SUBJECT: ISSUANCE OF AMENDMENT NO. 140 TO FACILITY OPERATING LICENSE NO.
DPR-35 - PILGRIM NUCLEAR POWER STATION (TAC NO. M80622)

This amendment revises the thermal and pressurization limit curves of Figure 3.6.1 and 3.6.2 of the technical specifications, and adds a new curve to Figure 3.6.3 to cover operations between 10 and 32 effective power years. Also included are changes to associated limiting conditions of operation, surveillance and bases sections 3.9 by letter of August 5, 1991 and sections 3.1, 3.2, 3.3 and 4.3, sections 3.5.C, D & E, and 3.10 by letter of October 4, 1991.

AMENDMENT TO FACILITY OPERATING LICENSE

SAFETY EVALUATION BY THE OFFICE OF NUCLEAR REACTOR REGULATION

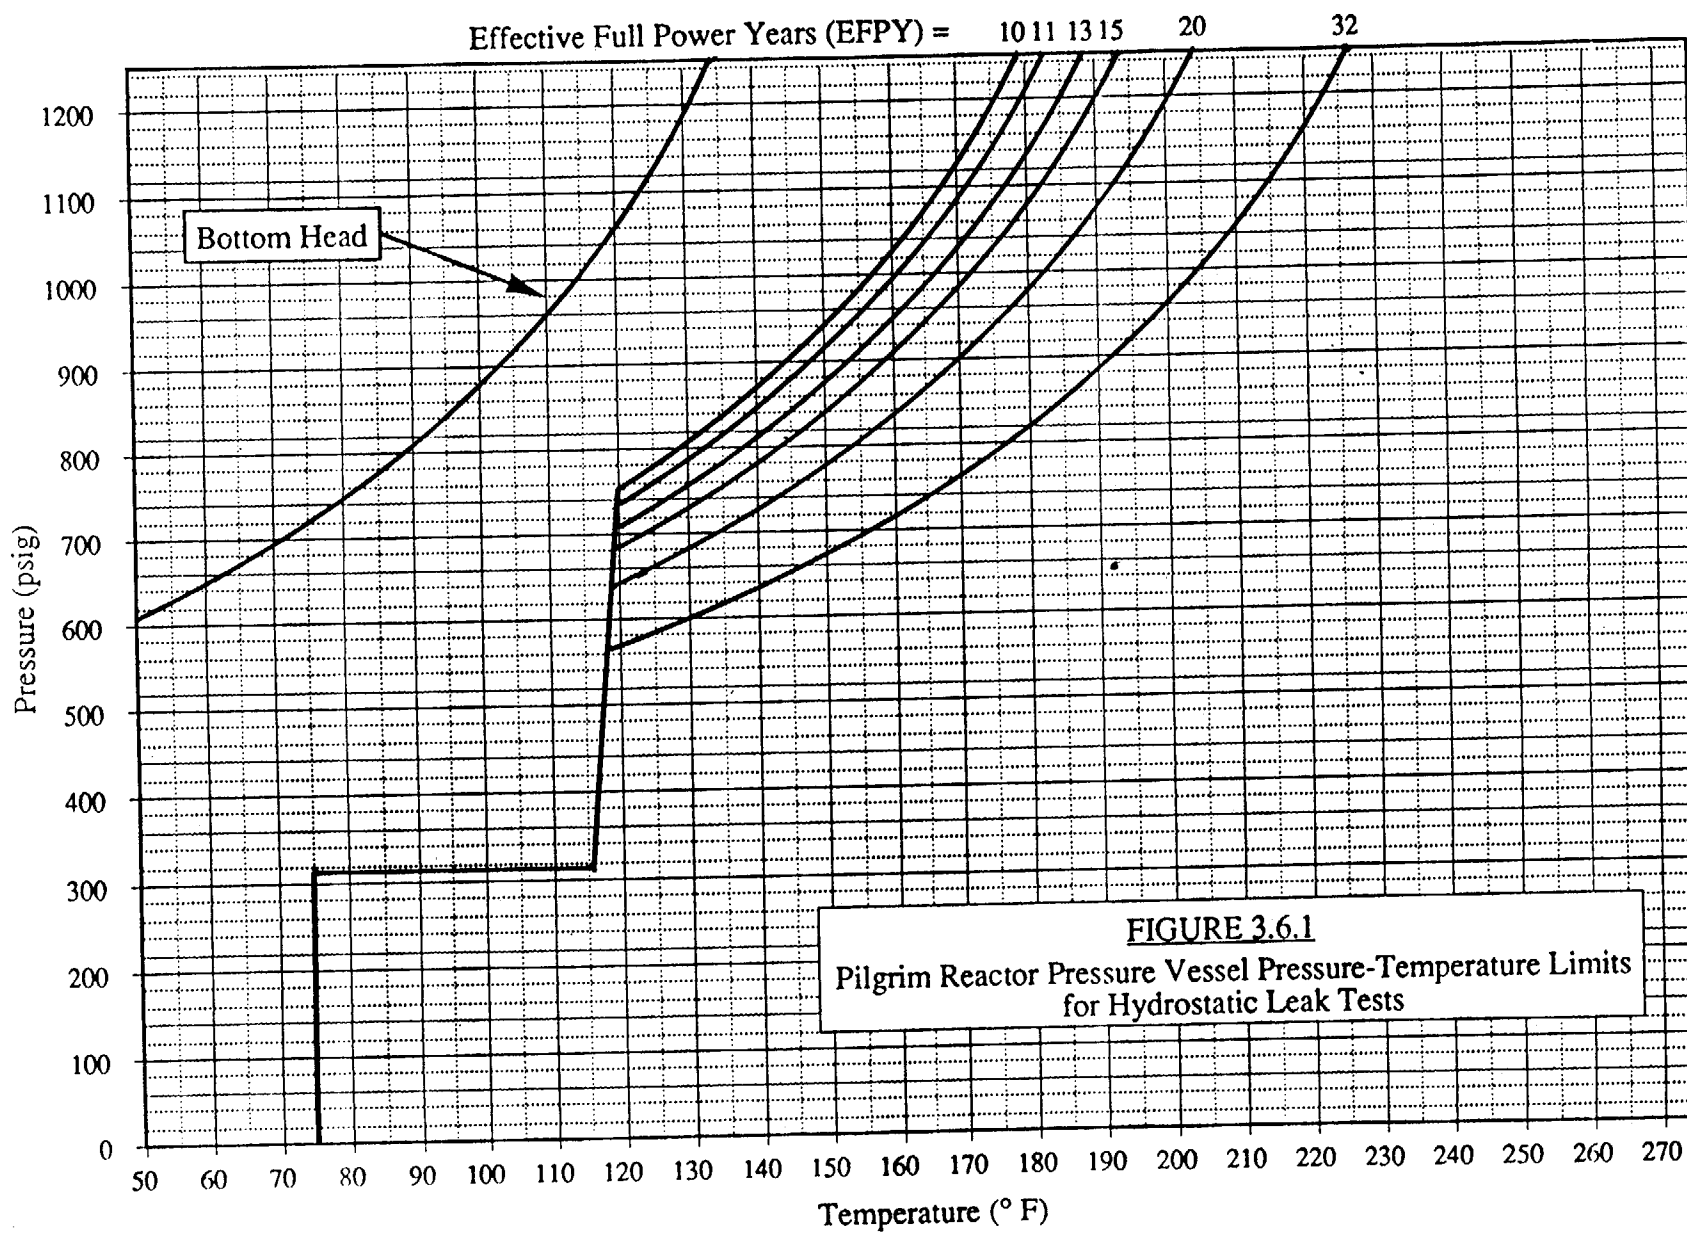
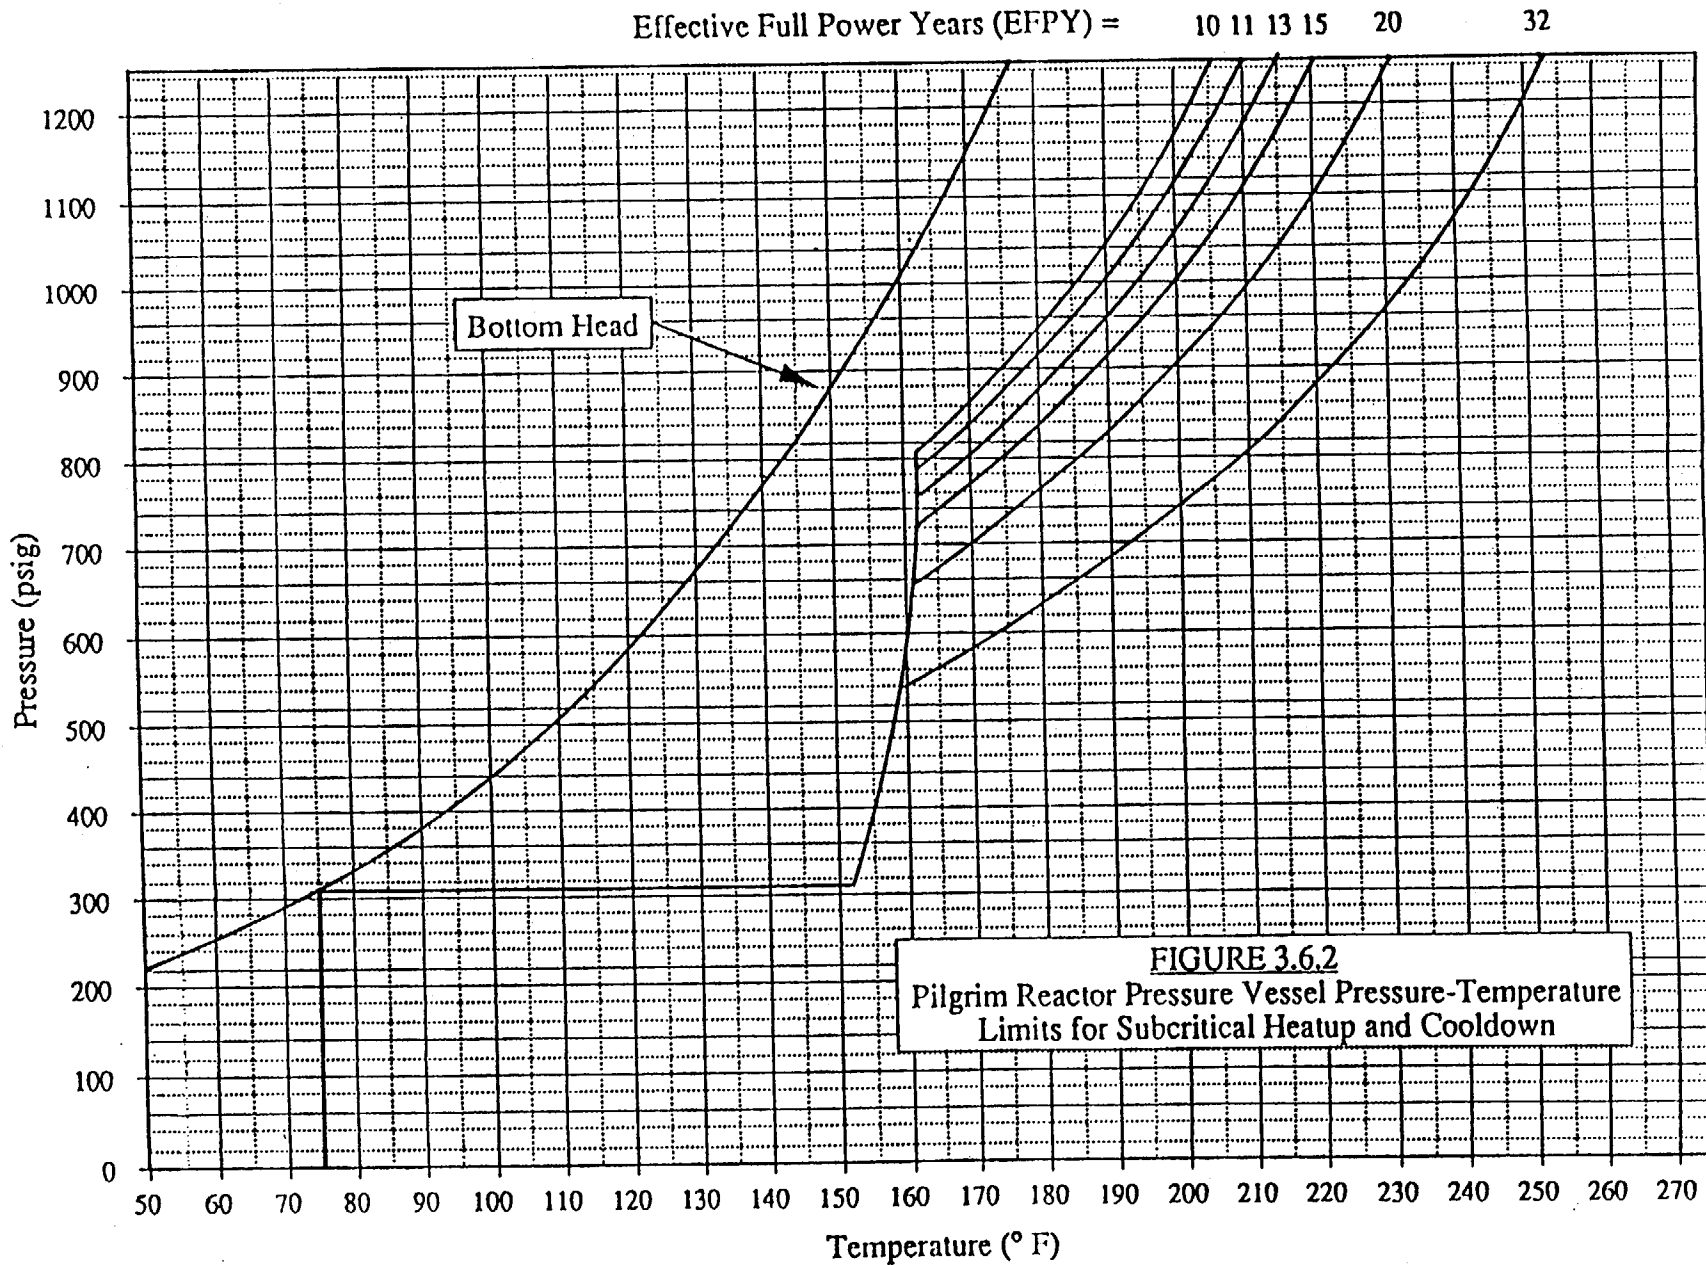
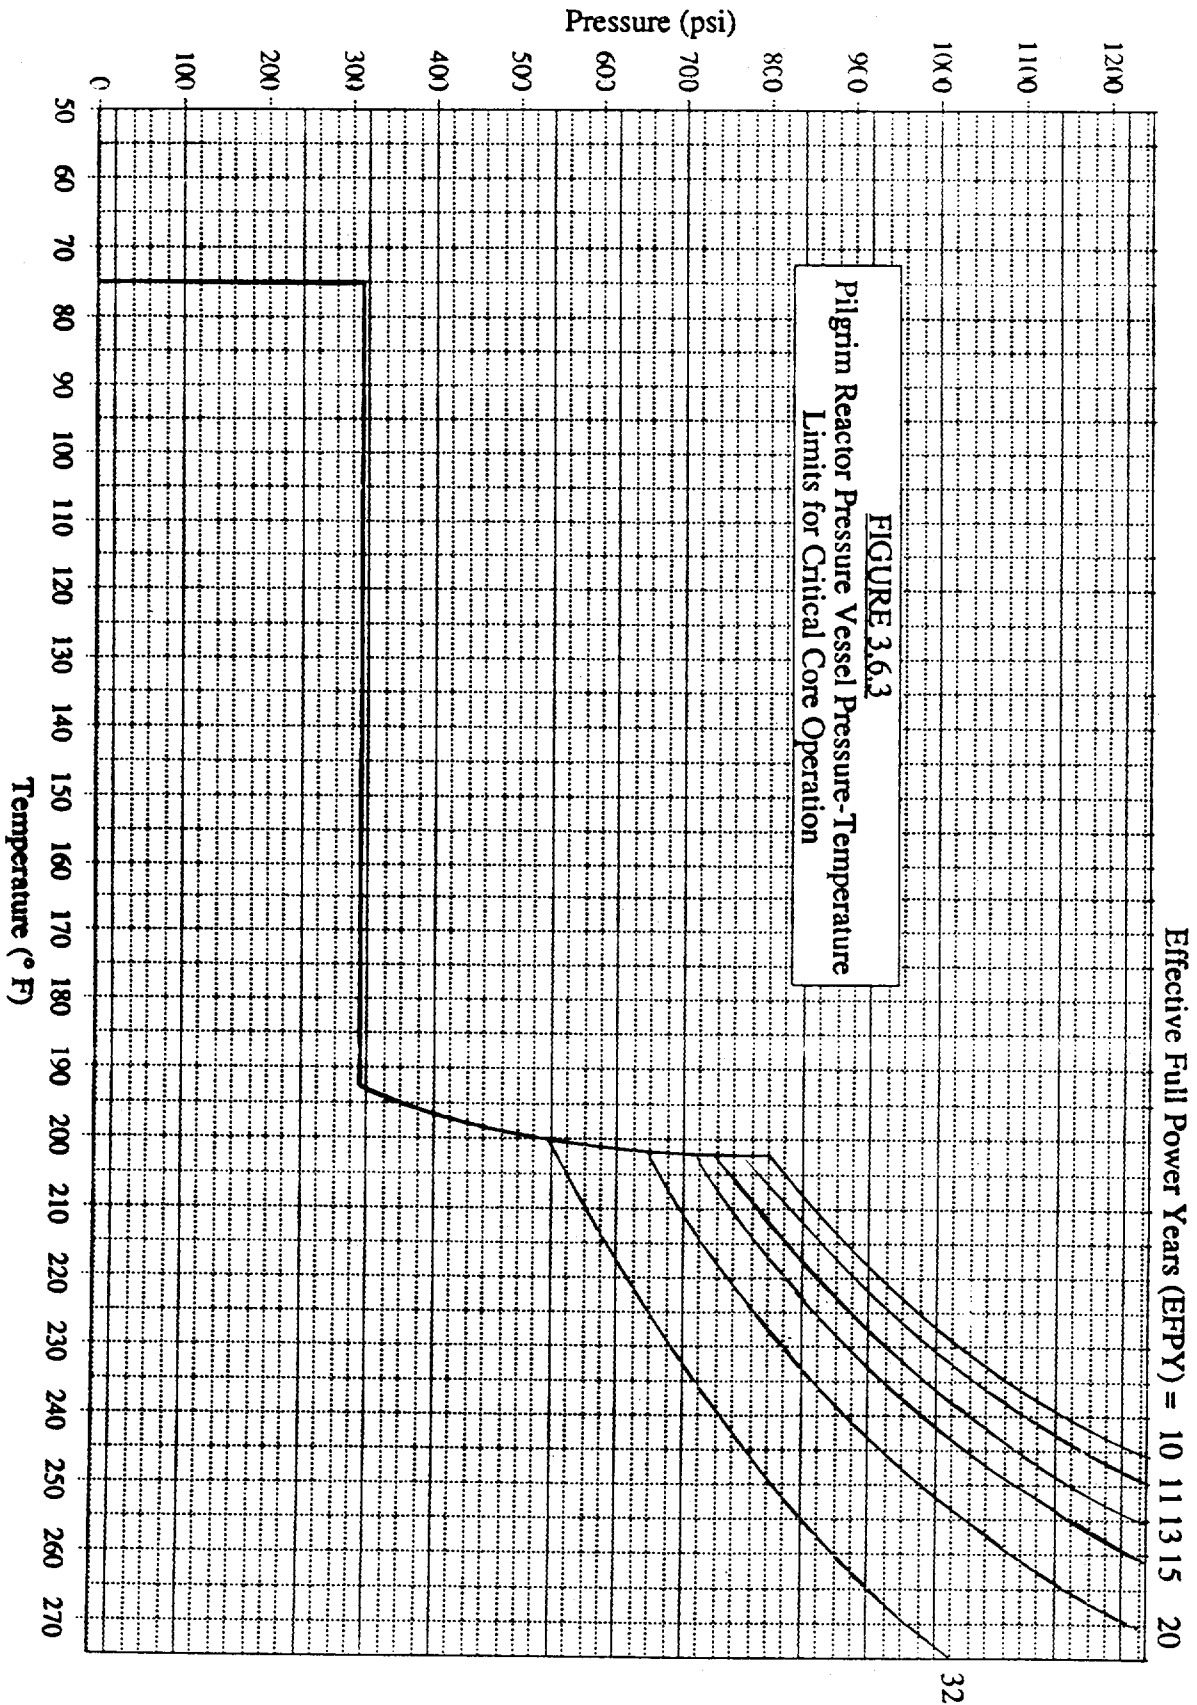
Appendix G to 10CFR50 defines the temperature-pressurization restrictions for hydrostatic and leak tests, pressurization, and critical operation. These limits have been calculated for Pilgrim and are contained in Figures 3.6.1, 3.6.2, and 3.6.3.

The licensee used the method in RG 1.99, Rev. 2, to calculate an ART of 91°F at 32 EFPY at $1/4T$ for the same limiting weld metal. The staff judges that the licensee's ART of 91°F is more conservative than the staff's ART of 90.9°F , and it is acceptable. Substituting the ART of 91°F into equations in SRP 5.3.2, the staff verified that the proposed P/T limits for 32 EFPY for heatup, cooldown, and hydrotest meet the beltline material requirements in Appendix G of 10 CFR Part 50. The staff also verified that P/T limits for 10, 11, 13, 15, and 20 EFPYs meet the Appendix G requirements.

In addition to beltline materials, Appendix G of 10 CFR Part 50 also imposes P/T limits based on the reference temperature for the reactor vessel closure flange materials. Section IV.A.2 of Appendix G states that when the pressure exceeds 20% of the pre-service system hydrostatic test pressure, the temperature of the closure flange regions highly stressed by the bolt preload must exceed the reference temperature of the material in those regions by at least 120°F for normal operation and by 90°F for hydrostatic pressure tests and leak tests. Paragraph IV.A.3 of Appendix G states "an exception may be made for boiling water reactor vessels when water level is within the normal range for power operation and the pressure is less than 20 percent of the pre-service system hydrostatic test pressure. In this case the minimum permissible temperature is 60°F (33°C) above the reference temperature of the closure flange regions that are highly stressed by the bolt preload." Based on the flange reference temperature of -5°F, the staff has determined that the proposed P/T limits for the 11, 13, 15, 20, and 32 EFPYs satisfy Section IV.A.2 of Appendix G.

In regard to the proposed bottom head P/T limits, the staff believes that because the bottom head of the reactor vessel does not receive significant amount of neutron fluence, embrittlement due to irradiation is not of major concern. The reference temperature calculations for the reactor beltline materials as prescribed in RG 1.99, Rev. 2 are not applicable to the bottom head P/T limits. The licensee calculated the stresses of the bottom head materials due to internal pressure, startup and cooldown transients, deadweight, and seismic loadings. The maximum stress locations are located at the junction between the lower torus and the support skirt and at control rod penetrations. From the maximum stresses, stress intensity factors and P/T limits were calculated based on ASME Code, Section III, Appendix G and 10 CFR 50, Appendix G. The staff finds that the licensee's calculation satisfy 10 CFR 50, Appendix G. However, to safeguard the structural integrity of the reactor beltline materials, the licensee must ensure that the pressure and temperature readings from the P/T sensors at the reactor vessel beltline region must be within the acceptable region of the beltline P/T limit curves when the bottom head P/T limits are being used during heatup and cooldown. The bottom head P/T limits must follow the same heatup and cooldown rate, 100 degrees F per hour, as that of the beltline P/T limits.
